## ANN ARBOR HISTORIC DISTRICT COMMISSION

### Staff Report

**ADDRESS:** 820 E Kingsley Street, Application Number HDC24-0013

**APPLICATION:** The applicant seeks HDC approval to construct a basement egress window and well on the south elevation by maintaining the width and increasing the depth of an existing basement window.

New vent location

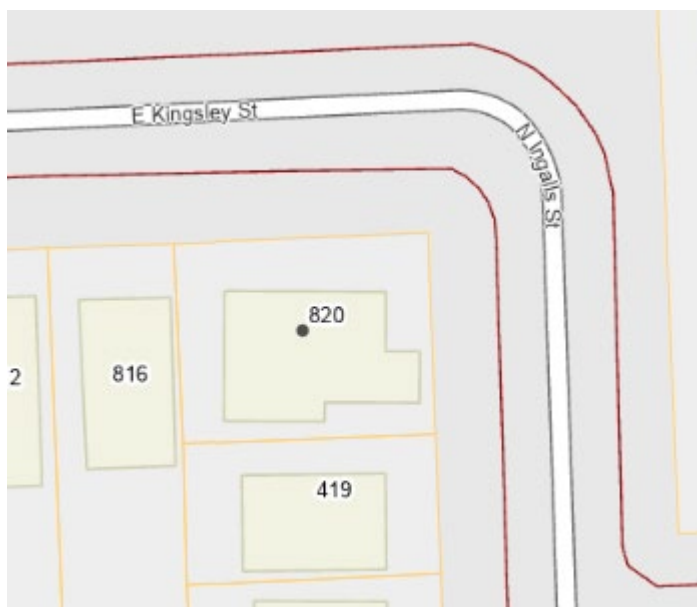
- 3) The vents would be relocated to the next basement window (about 10-12' farther back on the house), which is also boarded and has one vent pipe. The applicant provided the photo at right in an email that is attached to the record.
